AMENDMENT OF SOLICITATION/MODIFICATION OF CONTRACT

The purpose of this amendment is to extend the closing date for proposal submissions, make changes to the RFP and provide answers to questions received.

c. Specification Document **NCST-S-MI026D**:

Figure 3.2.6-8 - Design Loads - BAPTA Mechanism Rotating Side
(Assumes a Notional 7.4" Span Between Sewer Pipe and Lower X)

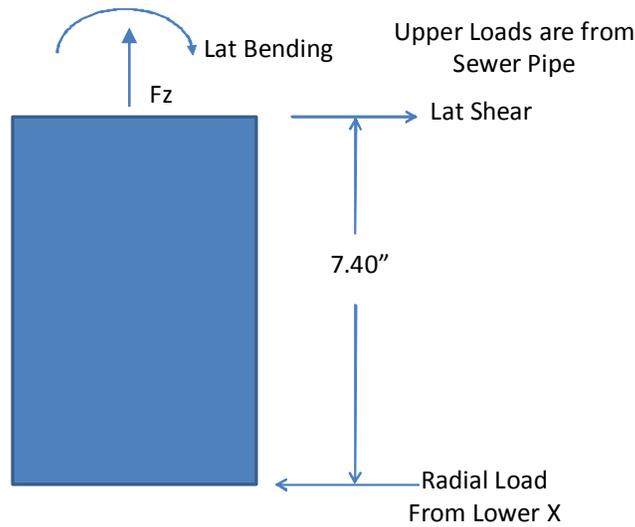
2. Figure 3.2.6-8 is revised as follows:

Figure 3.2.6-9 - Design Loads - BAPTA Mechanism Stationary Side

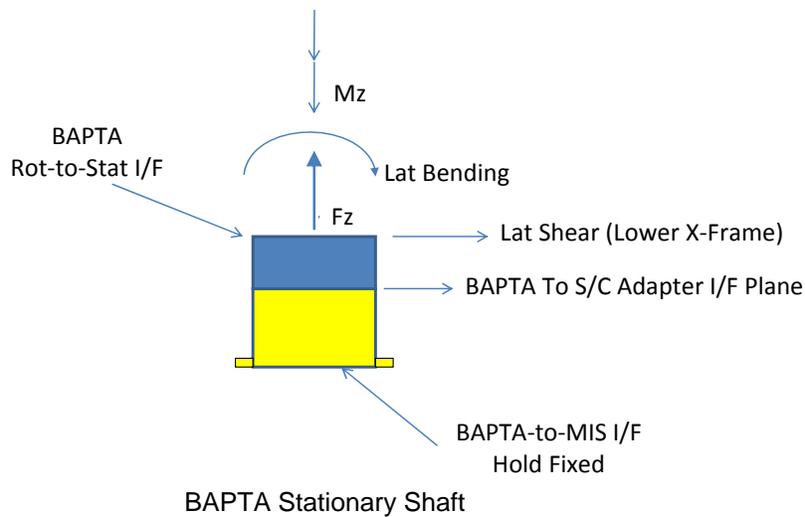
3. Figure 3.2.6-9 is revised as follows:

Figure 3.2.3-7 – BAPTA Electronics Envelope Options

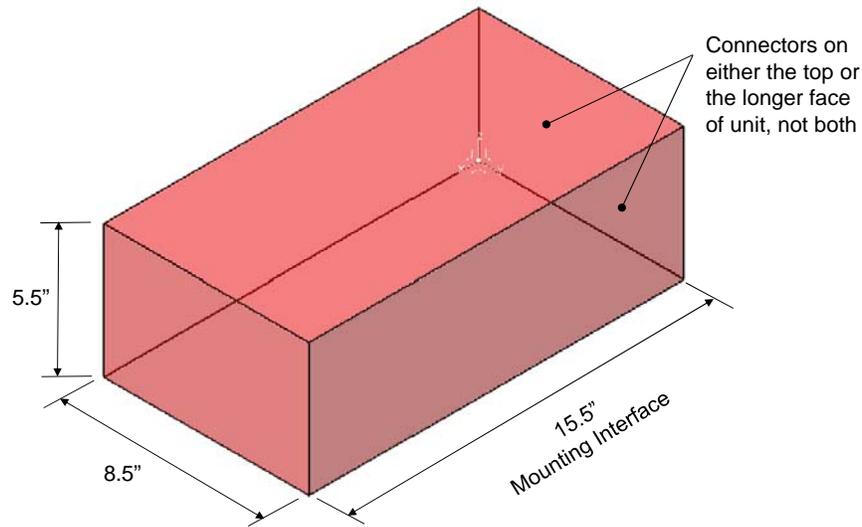
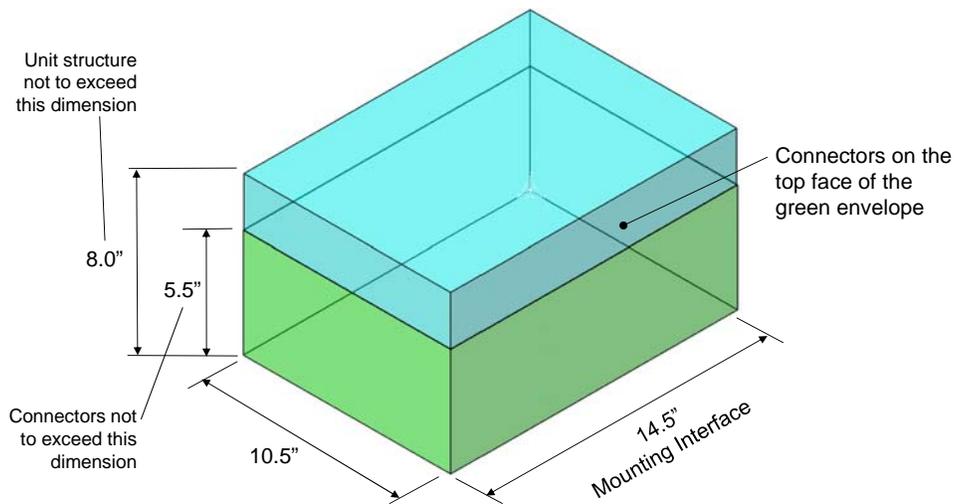
4. Table 3.2.1-1 for requirements S-MI026-10345 delete values “8 inches tall x 10.5 inches x 15.5 inches” and replace with “See Figure 3.2.3-7.”

5. Figure 3.2.3-7 is to be deleted and replaced with the following figure:

BAPTA-E Envelope Option #1

Envelope only applies for units with connectors on the top face

BAPTA-E Envelope Option #2
